VIRGINIA ELECTRIC AND POWER COMPANY
RICHMOND, VIRGINIA 23261

Serial No. 253
LQA/RMN:esh
Docket Nos. 50-280
50-281
License Nos. DPR-32
DPR-37

AMENDMENT TO OPERATING LICENSE
SURRY POWER STATION UNIT NOS. 1 AND 2
PROPOSED TECHNICAL SPECIFICATION CHANGE NO. 71
ADDITIONAL INFORMATION

VIRGINIA ELECTRIC AND POWER COMPANY
ORGANIZATION CHART
POWER OPERATIONS

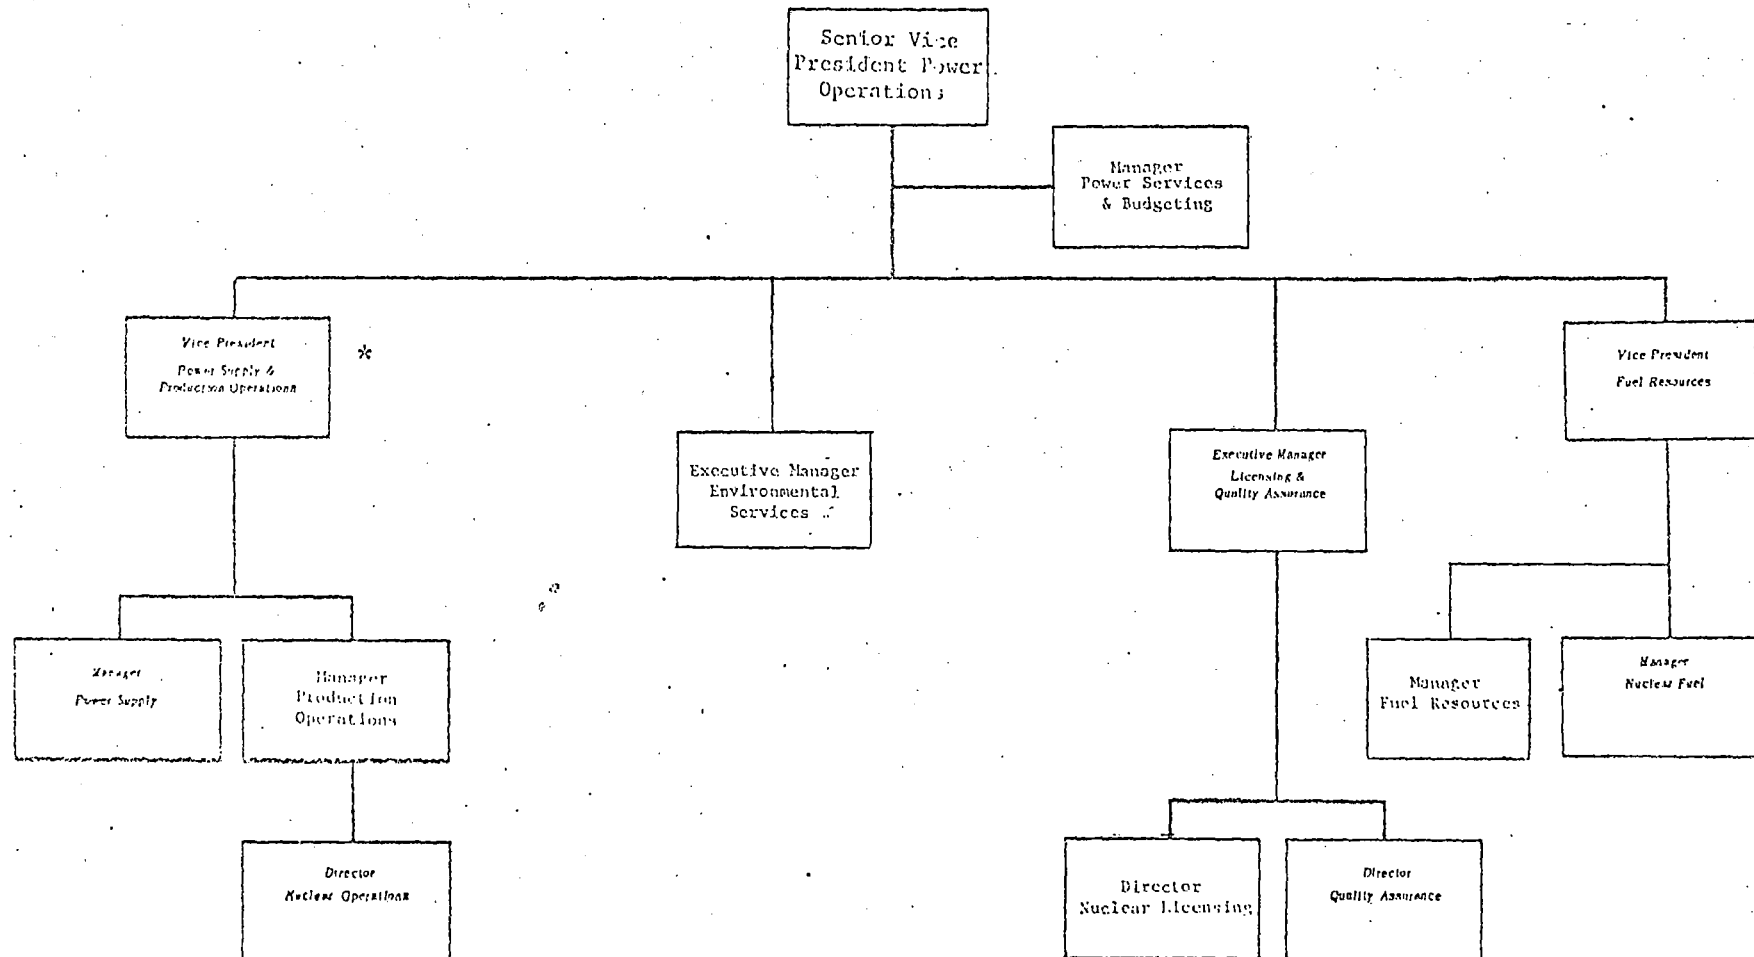
The August 31, 1978, submittal included a revised Figure 6.1-1, the Power organizational chart. There has been a management reorganization since then which is reflected in the attached revised Figure 6.1-1. The reorganization is designed to increase efficiency and therefore enhance safety.
